Time Delay Module Removal with Steltronic Scoring

Instructions to modify the current Brunswick A-2 electrical box by removing the Time Delay module and using a replacement cycle relay that plugs into a removable socket

Modified Connections to Eliminate the Time Delay Module

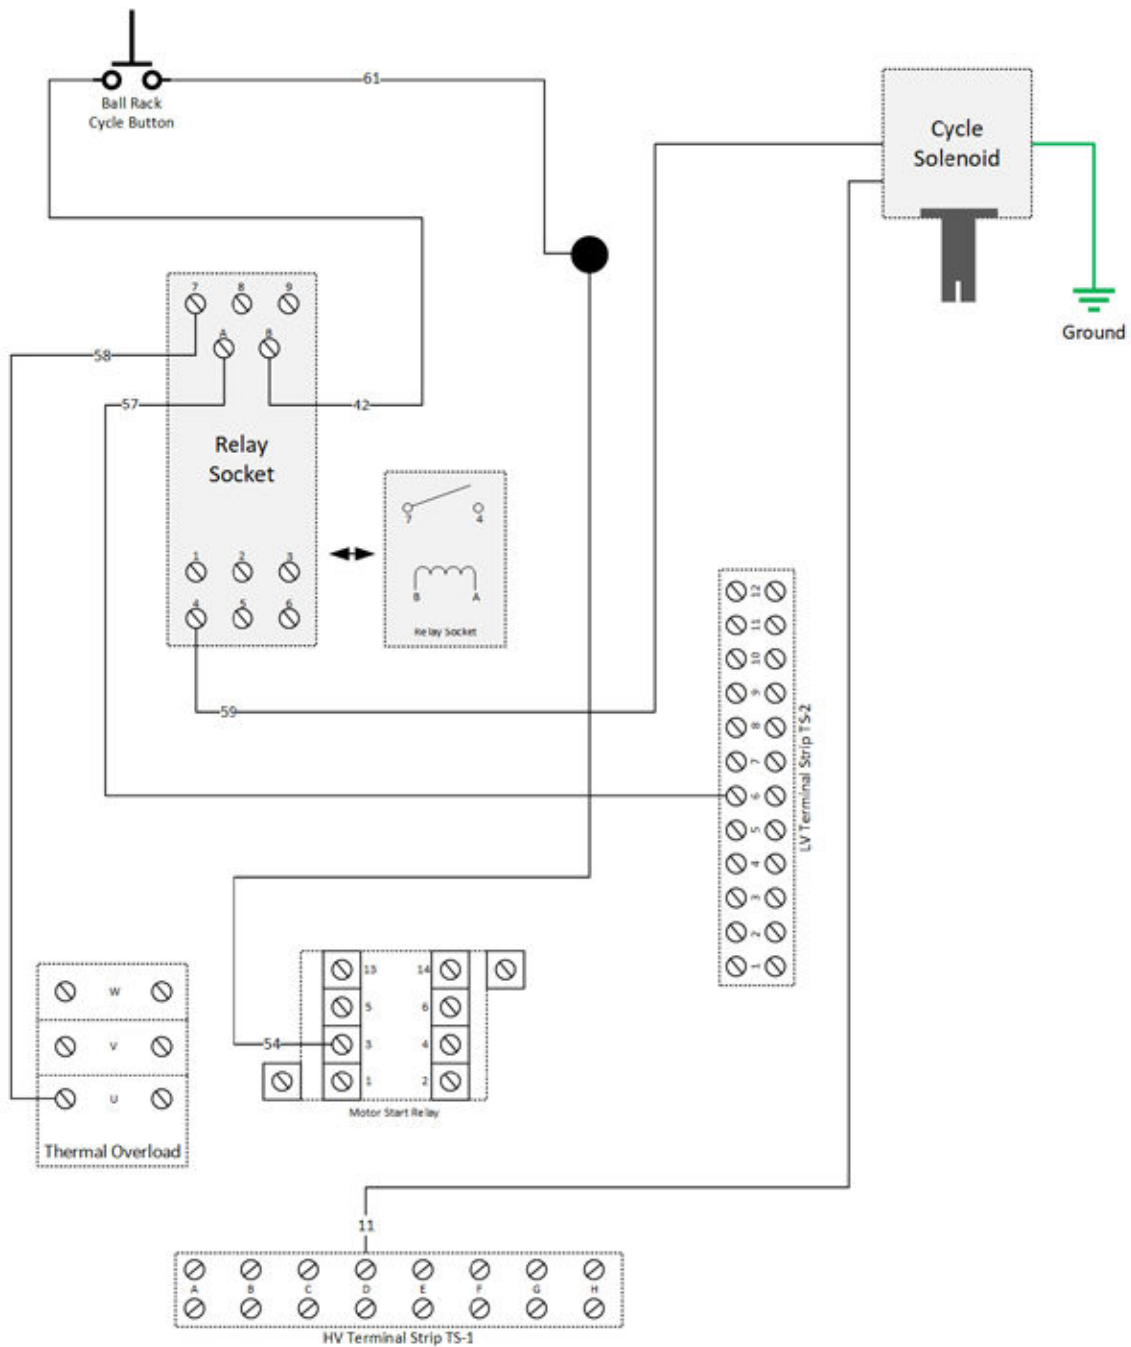
1. Remove wire 57 from TD Module terminal 13 and connect to terminal "A" on the relay socket that you purchased from Grainger.
2. Connect wire 42 to terminal "B" on the relay socket that you purchased from Grainger.
3. Connect both wires 54 & 61 together.
4. Remove wire 58 from TD module terminal 19 and connect to terminal "7" of the relay socket you purchased from Grainger.
5. Remove wire 59 from TD module terminal 20 and connect to terminal "4" of the relay socket you purchased from Grainger.
